Service Bulletin

RRP Service Bulletin No: RRP SB376

Title: Fuel Level Sensor Verification

Product Series: Advanced Tie Plate Inserters [ATPI]

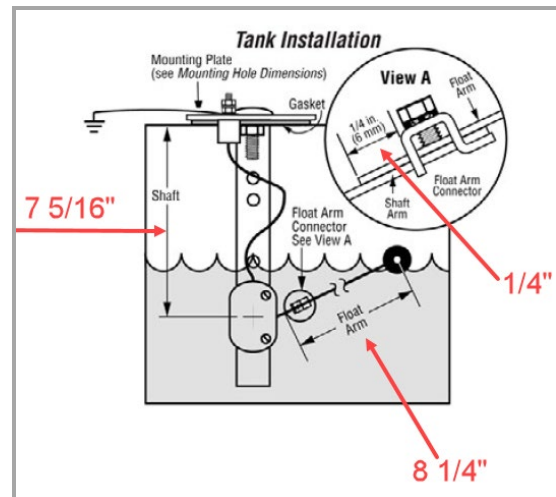
3. From bottom of sensor mount to pivot point of the float, verify the distance is 7 5/16".
4. Verify measurements of float arm to be 8.25" from center of the float to end of the arm.
5. Verify the float arm is 1/4" past the edge of the hold down screw. See image for details.
6. Reinstall the sensor and reconnect the wires.
